Informal document GRE-79-21  
(79<sup>th</sup> GRE, 24 - 27 April 2018,  
agenda item 7(a))

**India's comments submitted by the expert from India for the 06 series of amendments to Regulation No. 10 (Electromagnetic compatibility)**

**Document no ECE/TRANS/WP.29/GRE/2018/05**

A1) Annex 6, Appendix 1, figure replace:

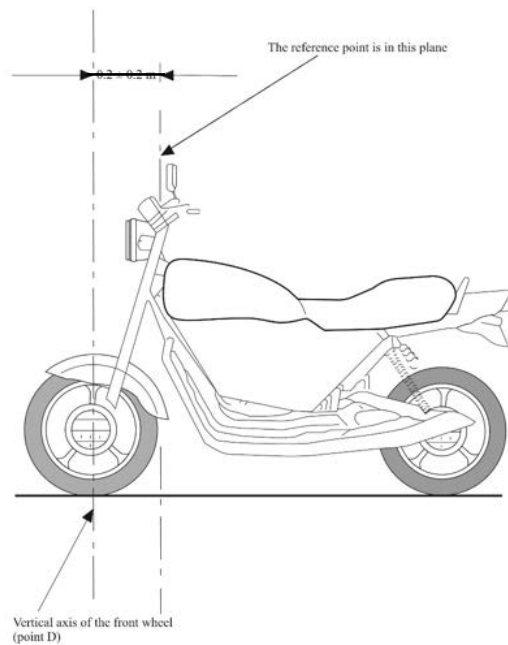
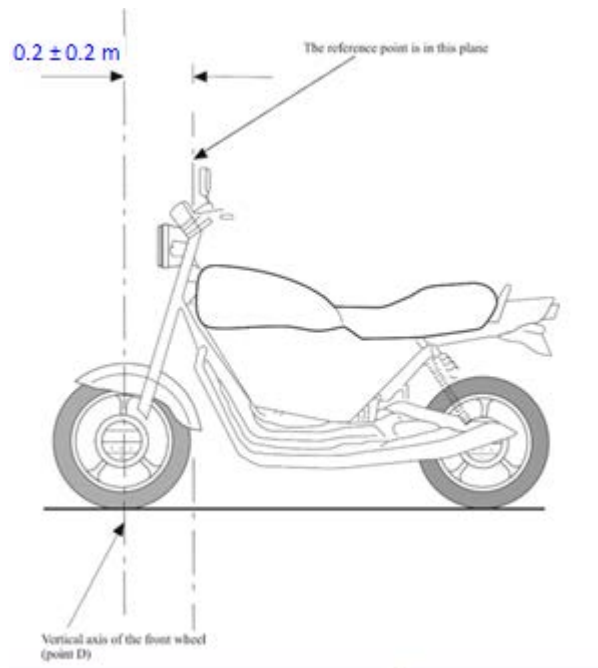
The text reproduced below was prepared by the experts from India to propose change in the UN Regulation 10 (Electromagnetic compatibility). This proposal is to change a figure as per EMC-TF document GRE-TF-EMC-12-06e R10.06\_Consolidated\_Rev4. India's proposals are marked in ~~strikethrough~~ for deletion of existing text and in ***bold italic text in blue colour*** for addition of new text.

To align as per Annex 6 – Appendix 1 figure 1 “Three wheeled vehicle” This was accepted in EMC-TF and was incorporated in in GRE-TF-EMC-12-06e R10.06\_Consolidated\_Rev. 4 dated 22.01.18
